IOWA DEPARTMENT OF TRANSPORTATION

IM-035-4(160)87--13-77

SUBJECT: Field Exam (D2)

NE 54TH AVENUE - INTERIM AND ULTIMATE

ENGLISH IOWA DOT DESIGN TEAM HDR\Iowa DOT POLK COUNTY PROJECT NUMBER IM-035-4(160)87--13-77 SHEET NUMBER B.2

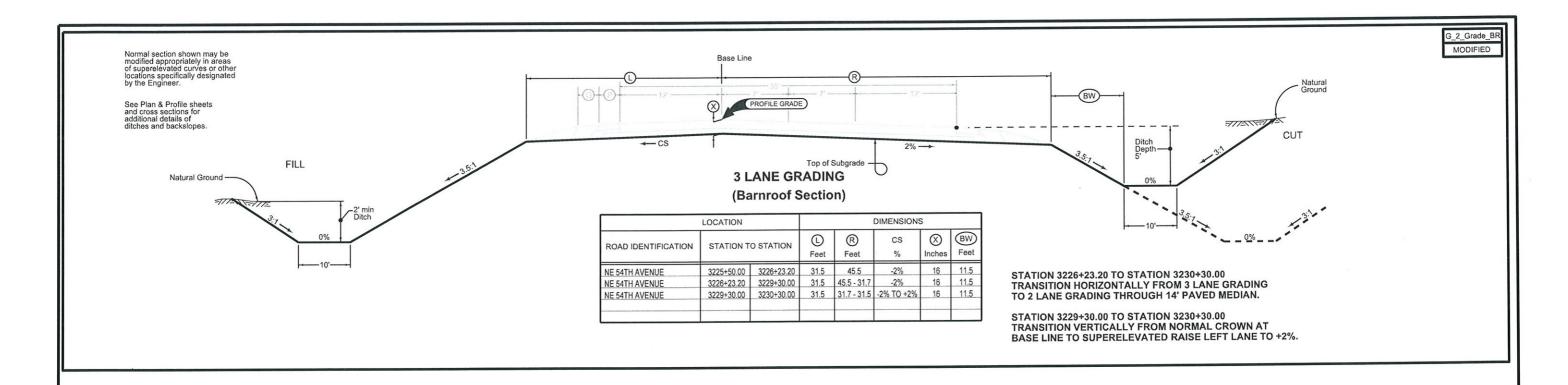
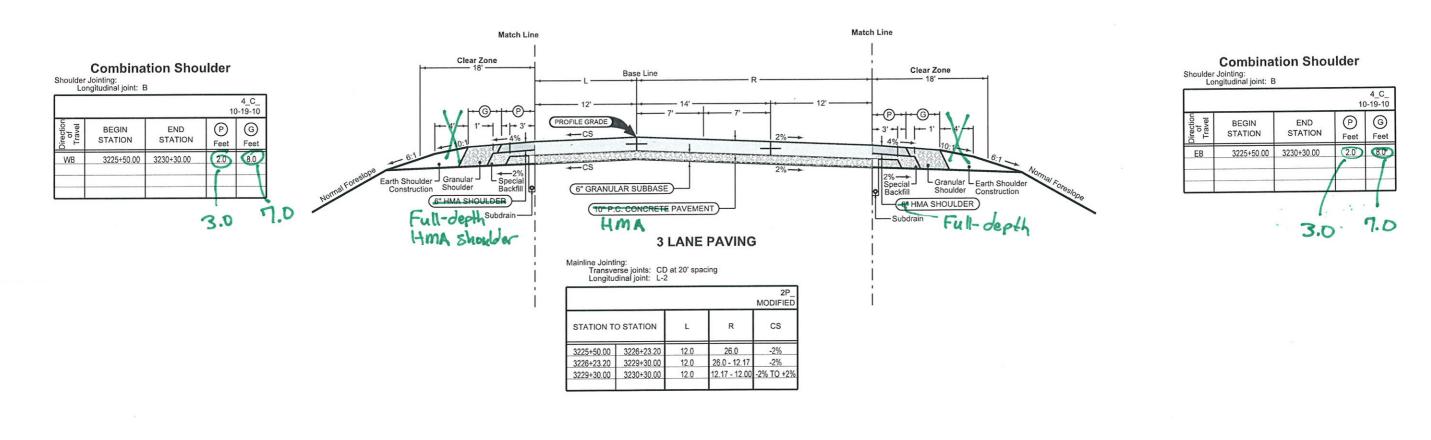
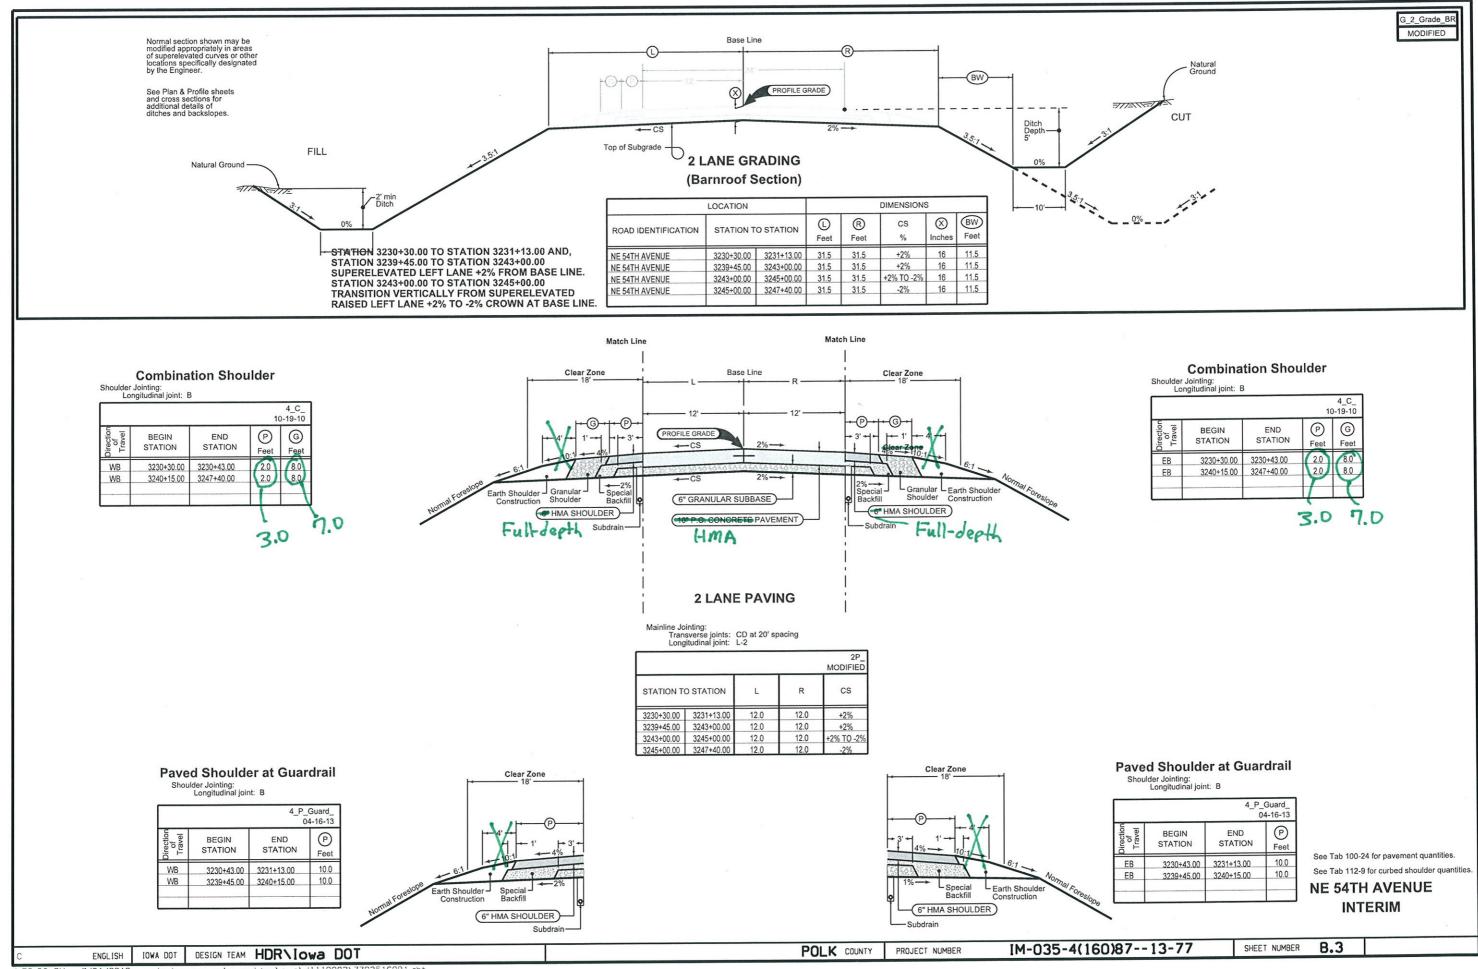
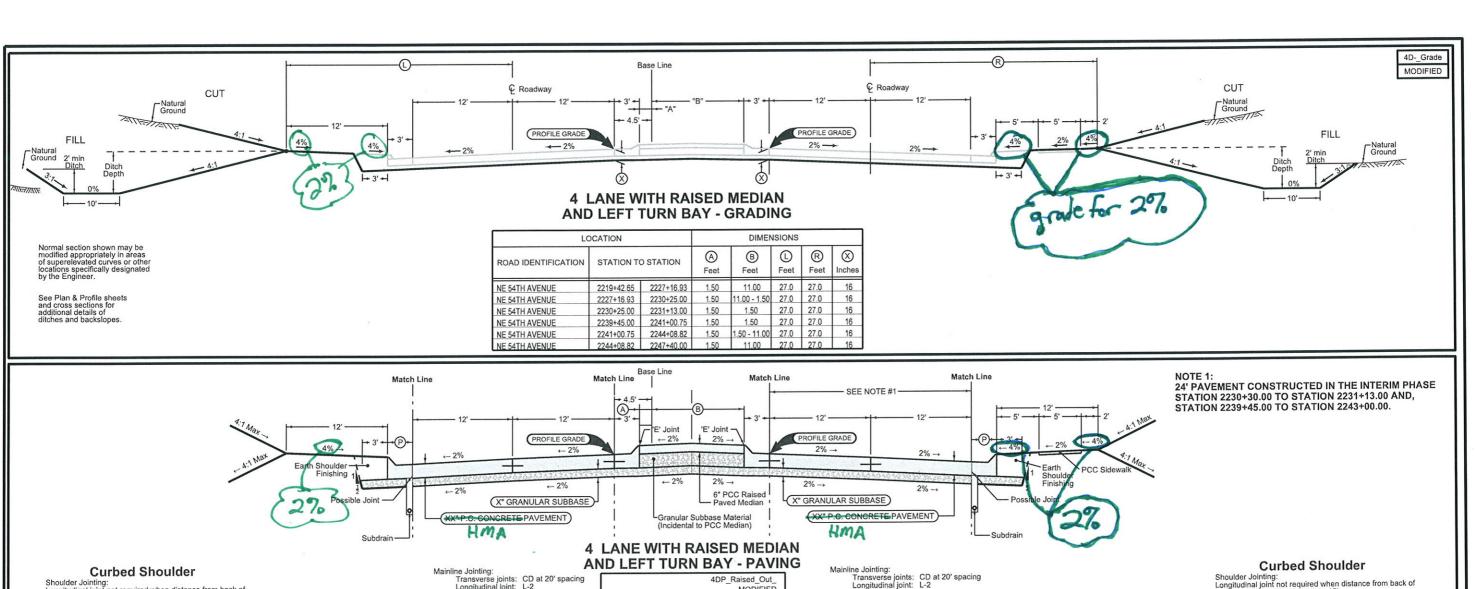
Per discussion at the meeting, Polk County noted the sidewalk is not required on NE 54th Avenue in the ultimate condition. The typical section will provide for the grading and a sidewalk can be paved at a later date, if desired. For this design, the sidewalk will be eliminated from the plans.
